2/22/2016

Additional questions submitted by vendors for the PSIM RFP. Answers are in red

ADDITIONAL CAMERAS TO BE ADDED AND INCLUDED IN THE CCTV SYSTEM

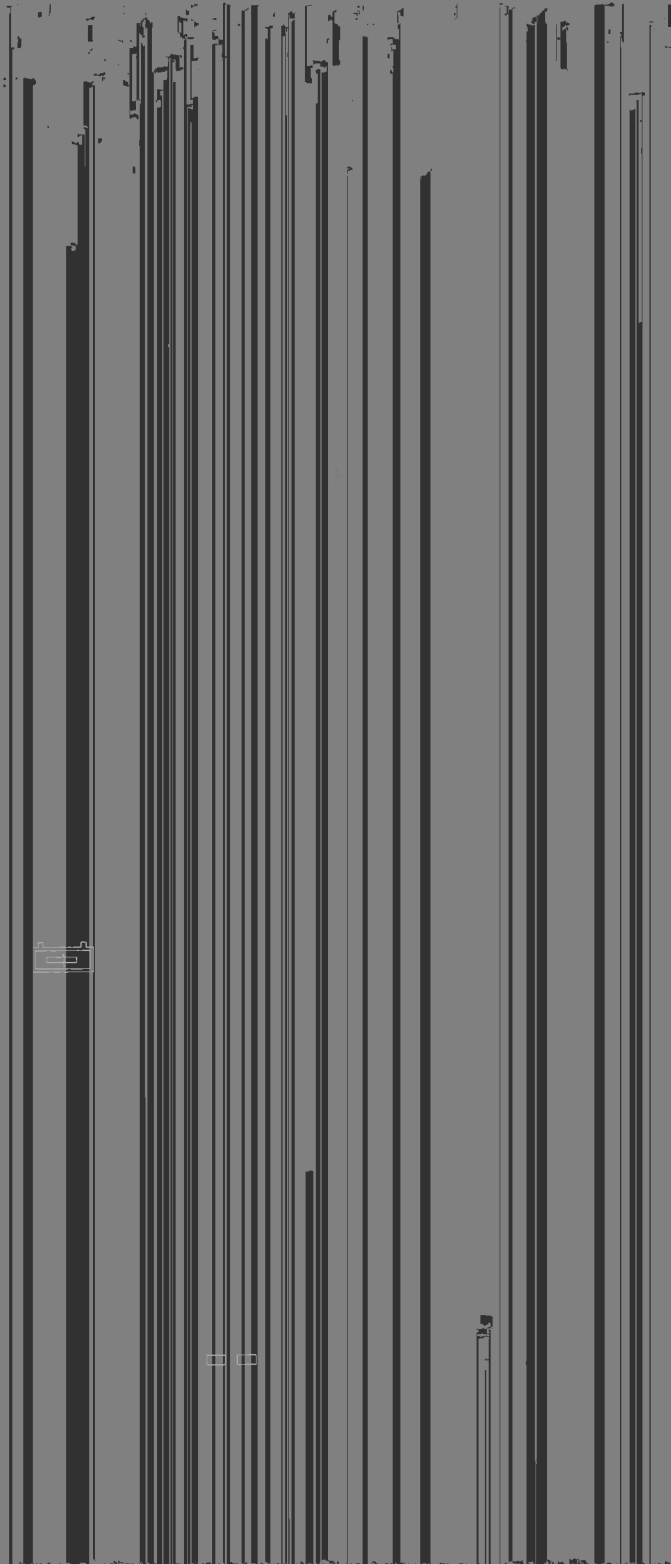
- 3) Do you want the new display camera and monitor in the corner of the desk to be incorporated into the CCTV system? **YES, AS WELL AS THE ONES IN THE DIAGRAM ATTACHED.**

Vendor to provide cameras and materials for installation.

[Redacted]	or equivalent
[Redacted]	chen Sallyport entrance
[Redacted]	Sallyport
[Redacted]	holding
[Redacted]	ell
[Redacted]	ions
[Redacted]	ount or equivalent
[Redacted]	ig Jail Admin & kitchen door
[Redacted]	ig Booking & Sallyport entrance
[Redacted]	ig tower 1 floor & Jail Sgt entrance
[Redacted]	ng Medical entrance
[Redacted]	y to Court Holding
[Redacted]	ourt Holding
[Redacted]	rney Booth hallway
[Redacted]	1 General Sessions by Juvenile Detention to Court Holding.
